Item Name: Replacement Skidtube

DRAWING NO. D2580	TITLE 205 SKIDTUBE ASSEMBLY	REV. E	DART AEROSPACE LTD ENGINEERING ORDER	D.E.O. NO. D2580-E-1	SHEET NO. SHEET 1 OF 1	SCALE NTS
DRAWN <i>UP</i>	CHECKED <i>ASS</i>	MFG. APPR. <i>EC</i>	APPROVED <i>[Signature]</i>	DE APPR. <i>[Signature]</i>		
DATE 11.12.13	DATE 11.12.13	DATE 11.12.13	DATE 11.12.13	DATE 11.12.13

CHANGE ALL C'BORED WELDED CROSSBOLT SPACERS TO SWAGED SPACERS

SECTION B-B, F-F, I-I
NOT TO SCALE

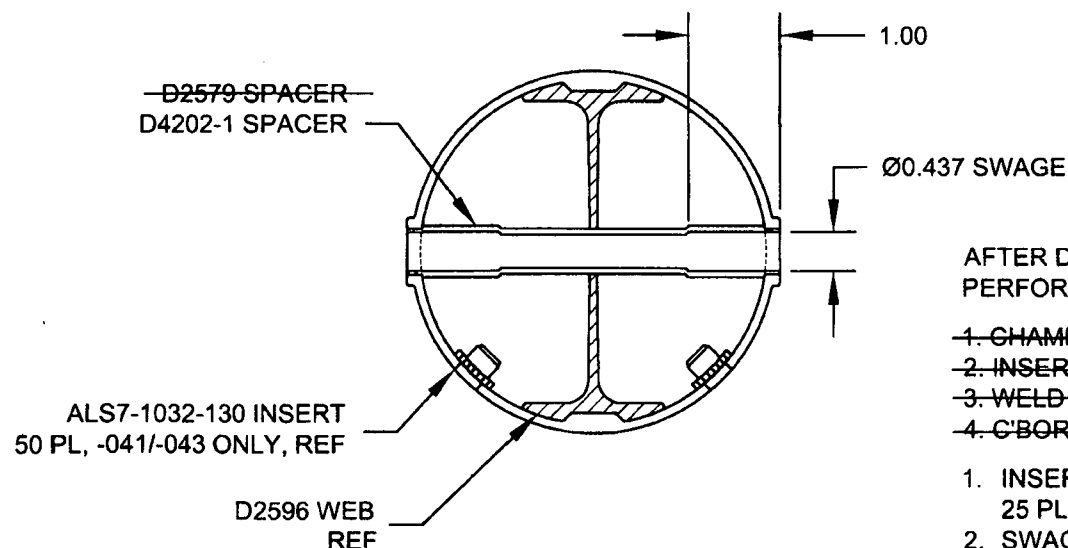
SECTION B-B, SECTION F-F, & SECTION I-I ARE AMENDED AS FOLLOWS
FOR ALL HOLES THAT WERE ORIGINALLY C'BORED:

*** FOR -045 SKIDTUBE ONLY:**

WELD 4X D2579 SPACERS PER DWG
IN LOCATIONS MARKED "NO C'BORE".
REF SHEET 4 OF DWG.

1. INSERT D4202-1 SPACER, 20 PL (-041) OR 20 PL (-045) OR 25 PL (-047)
2. SWAGE TO Ø0.437 X 1.00 DEEP PER QSI 002
3. TRIM / GRIND FLUSH PER QSI 002
